Safety Alert: Hydraulic Hoist Cylinder Failure on Komatsu 680-E Trucks

Hoist Cylinder Failure

EQUIPMENT: All 445E, 510E, 630E, AND 685E HAULPAK® Trucks with "Super Cylinder" Hoist Cylinders

SUBJECT: Product Improvements to Hoist Cylinders

FIGURE 1. CYLINDER, 3rd STAGE

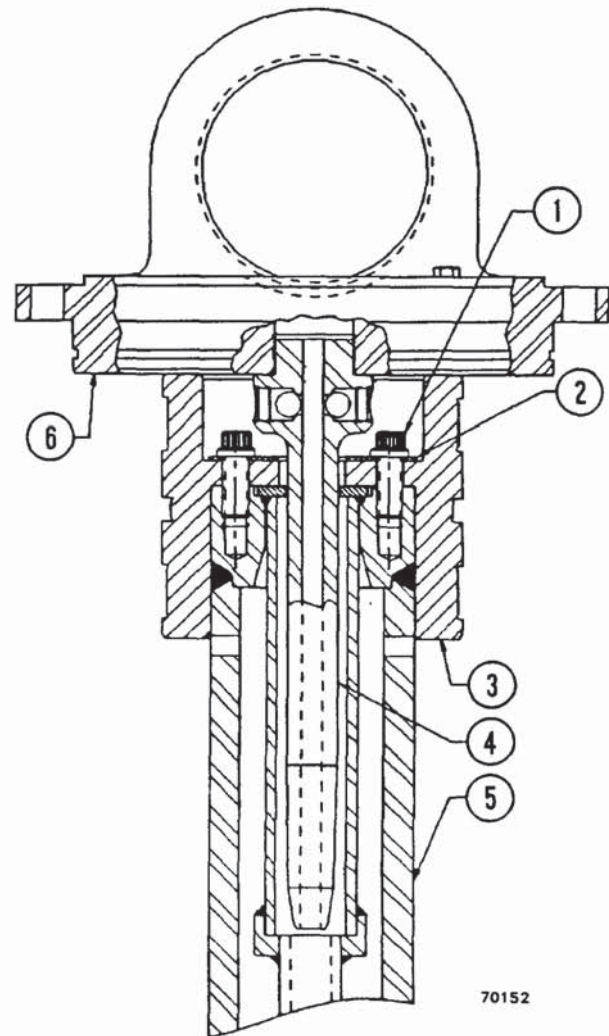
The Hoist Cylinder Rework Kits, MK3567 for the 630E and 685E and MK3569 for the 445E and 510E, provide the parts and instructions for improving the method of retaining the third stage piston bearing retainer. On existing cylinders, the retainer is held by six 5/8" UNC grade 8 hex head capscrews with hardened flat washers. The new method uses twelve 5/8" UNRC grade 9, twelve point capscrews (1, Figure 1) and a single, hardened washer plate (2). This provides a significant increase in the clamping force exerted on the piston bearing retainer (3).

When a cylinder is disassembled, the Rod Eye Structure (5) should be modified according to rework drawing ED5217 for the 630E/685E or ED5201 for the 445E/510E which adds six more tapped holes. When reworking the Rod Eye Structure, plug all external piston openings to prevent internal contamination. A new bearing retainer ED5224 will be required (3). The quill assembly (4) must be removed from the cylinder head (6) and chamfered as shown on rework drawing ED5219. After modification, the following parts should be renumbered with the same part numbers as used in the production cylinders, but with a prefix "R" in front of the number to indicate a reworked part.

1. Make certain threads on capscrews and threads in rod eye structure are clean and dry (free of oil and solvent).
2. Using Loctite 'LOCQUIC' Primer "T" (TL8753, or equivalent), spray mating threads on capscrews and threads in rod eye structure.

3. Apply Loctite Sealant #277 (VJ6863, or equivalent) to mating threads of both capscrews and threads in the rod eye structure.
4. Install capscrews (1, Figure 4) and hardened washer plate (2) and tighten capscrews to 250 ft. lbs. (209 N.m) torque.

Allow parts to cure for 2* hours before exposing threaded areas to oil
